ADDENDUM M-4

Project: Access PEI Summerside Heating System Upgrade

Owner: Province of Prince Edward Island – TIE

7 PENTHOUSE - DEMOLITION LAYOUT (PHASE 5)

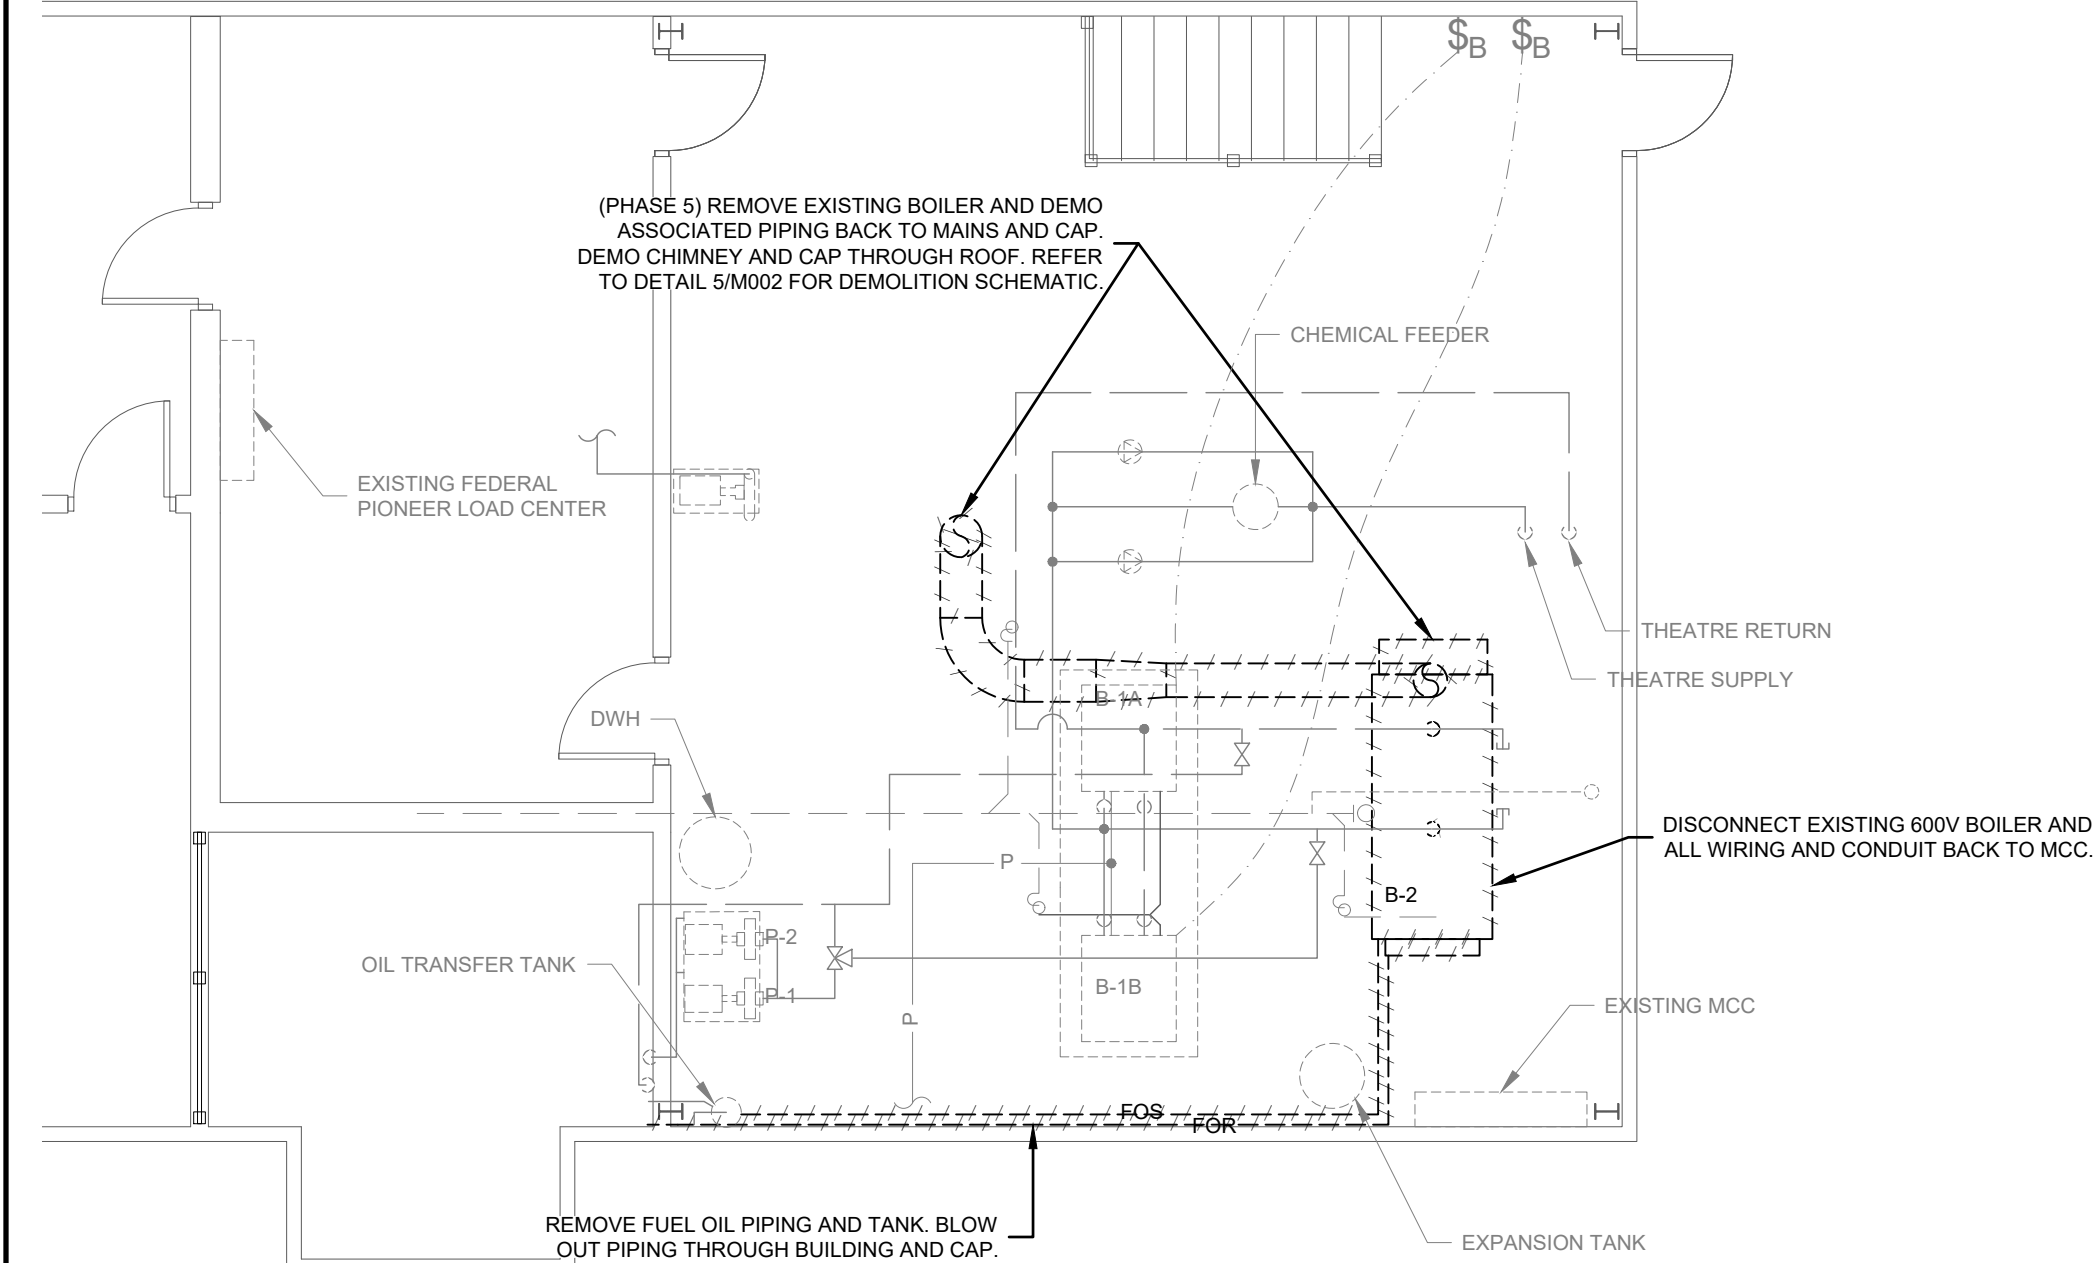
- i. New boiler disconnect switch to be installed in place of previous boiler disconnect.
 - ii. Connect new boiler to new 20A/1P breaker in existing Federal Pioneer Load Centre.
- b. Refer to the drawings for additional changes as shown.
- 3. Refer to 7/M103.
 - a. Add the following note: Disconnect existing 600V boiler and all wiring and conduit back to MCC.

2 PENTHOUSE - DEMOLITION LAYOUT (PHASE 2)

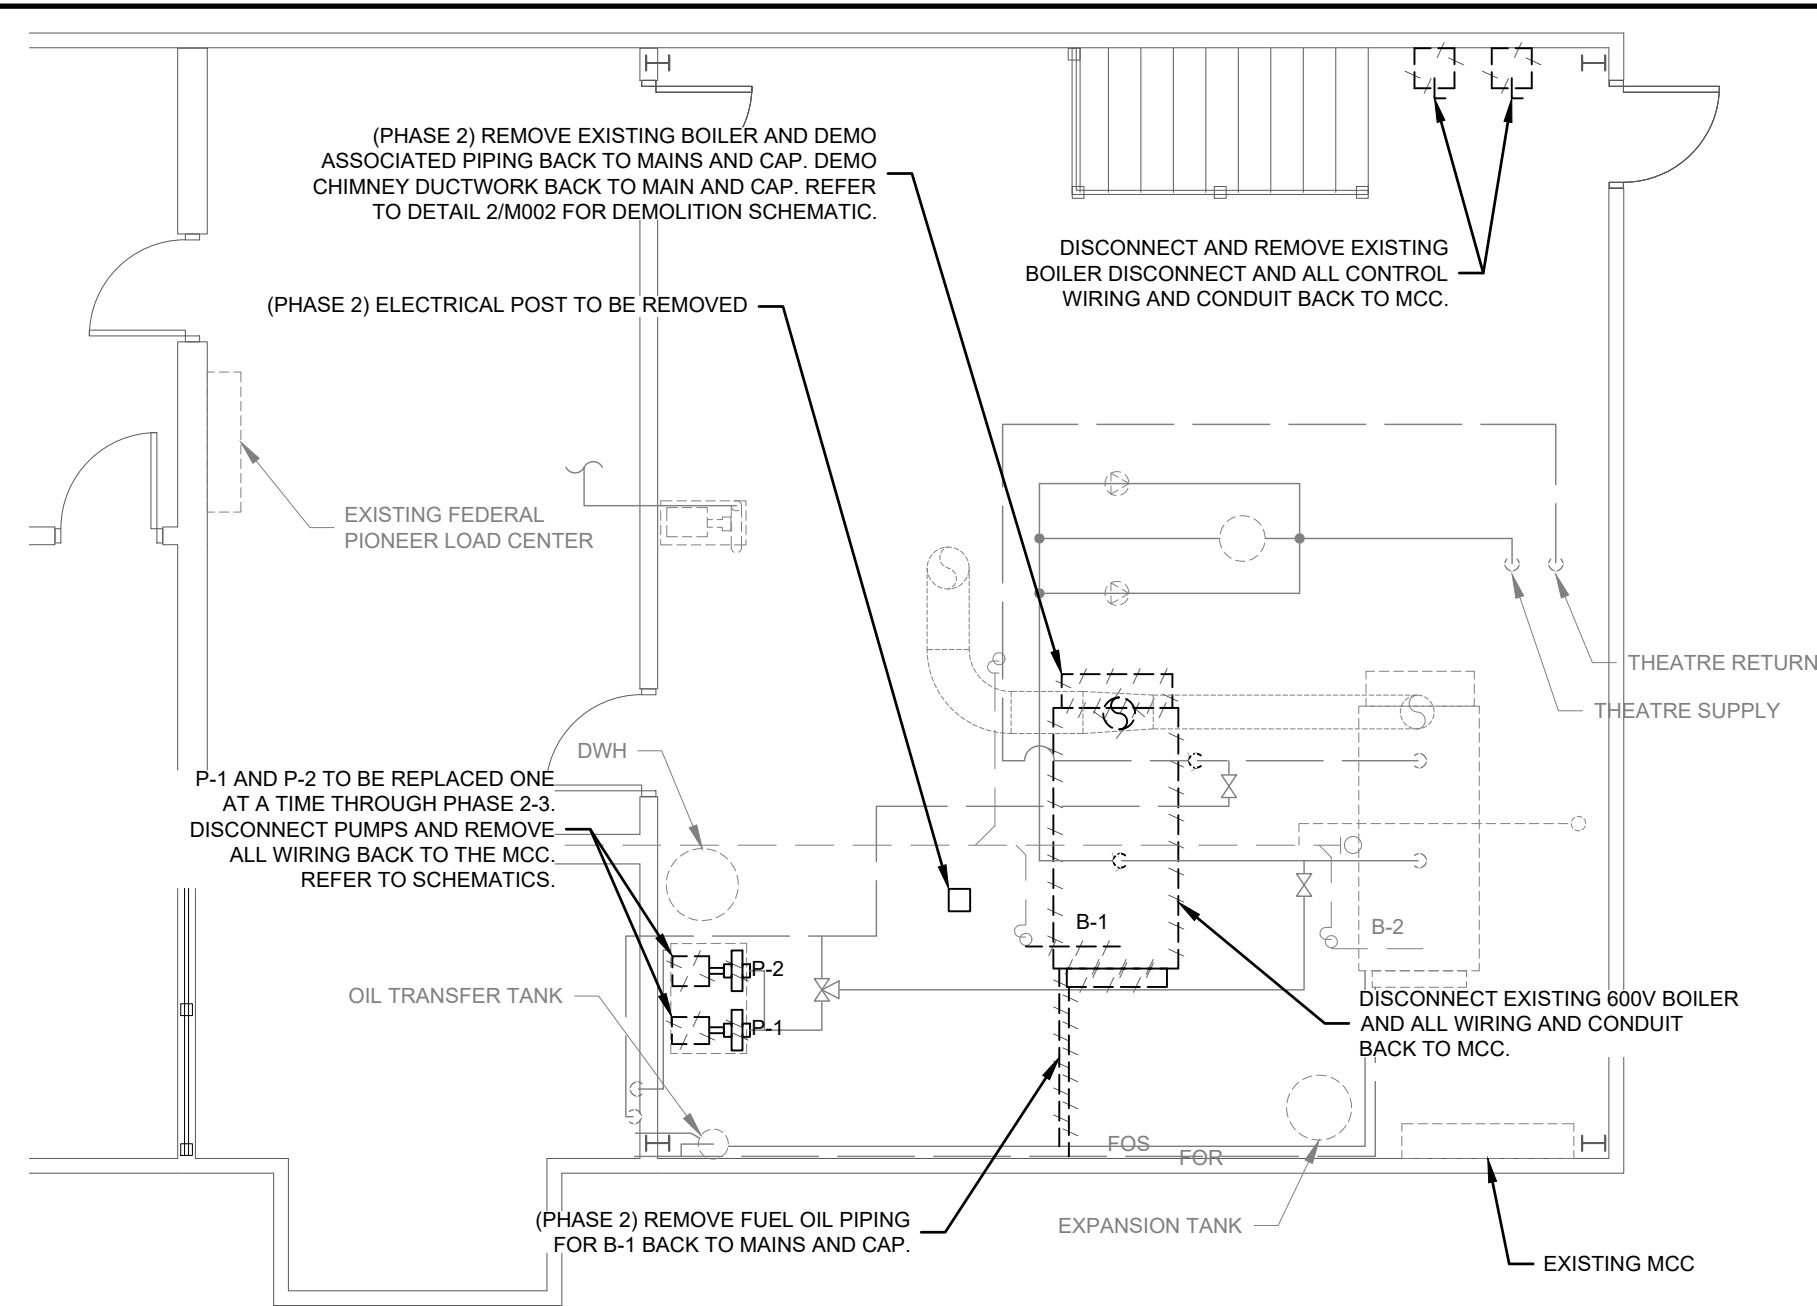
1. Refer to 2/M103.
 - a. Add the following notes:
 - i. Disconnect and remove existing boiler disconnect and all control wiring and conduit back to MCC.
 - ii. Disconnect existing 600V boiler and all wiring and conduit back to MCC.
 - b. Refer to the drawings for additional changes as shown.
2. Refer to 3/M103.
 - a. Add the following notes:
